Aman Graphics & Designs Ltd. (Extension)

Najimnagar, Hemayetpur, Savar, Dhaka.
Geographic Coordinates: (23.793061, 90.264437)
16 July 2023

Truss Layout plan

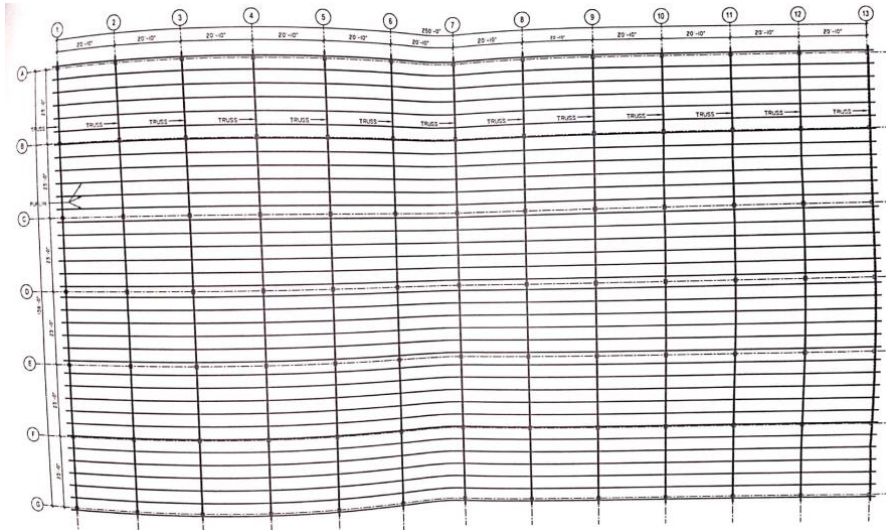
During inspection, mismatch found in truss layout plan. In shed 4 there were 14 number of truss found but in as built drawing only 13 number of truss shown. Building engineer is required to survey the full structure and update the as-built drawing accordingly.

Dampness was found on periphery wall

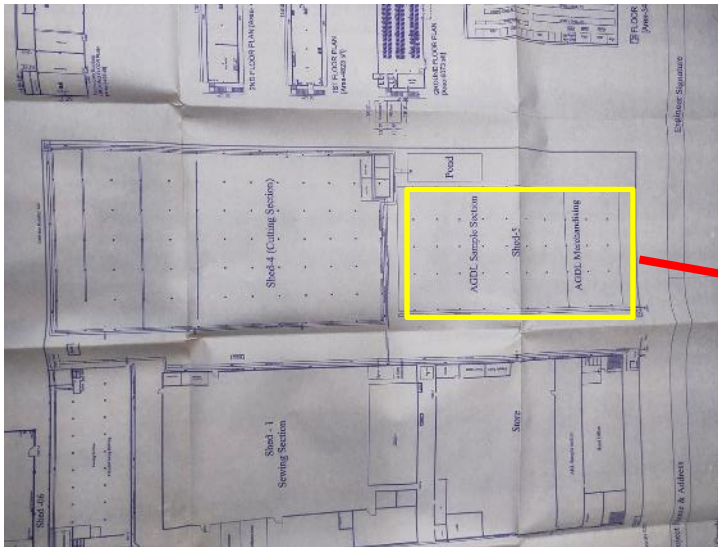
Dampness was found on periphery brick wall of shed 4.
Factory is required to repair all damp areas as per
suggestion of building engineer.

Lack of anchorage of storage rack

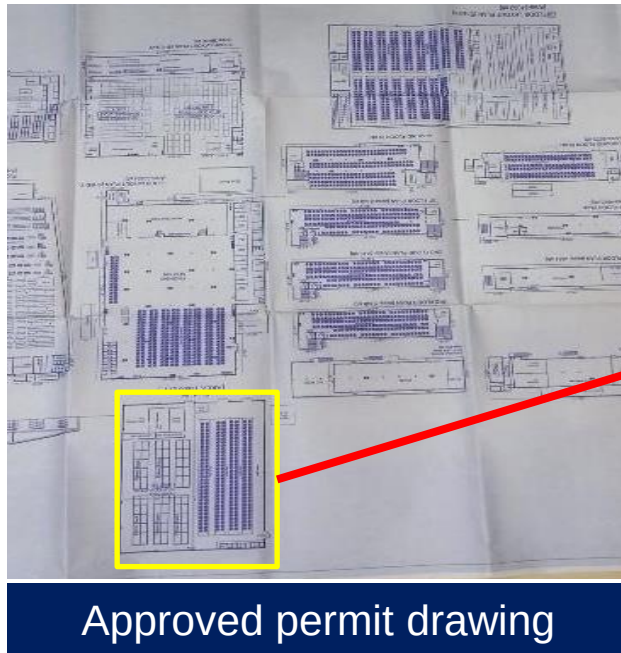
During inspection Lack of anchorage of storage found on shed 5. Building engineer required to brace/anchor all the non-structural elements.

Lack of lateral stability

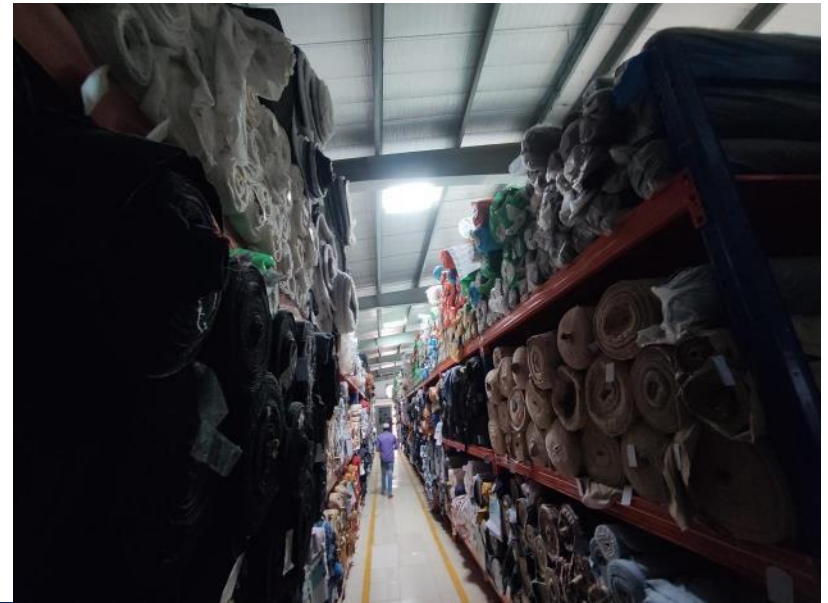
Portal/Moment resisting frame is only provided along short direction. Lateral Stability.

No bracing was provided along long direction.

Portal/Moment resisting frame is only provided along short direction. No bracing was provided along long direction at roof structure. Building engineer is required to check the lateral stability of the structure.
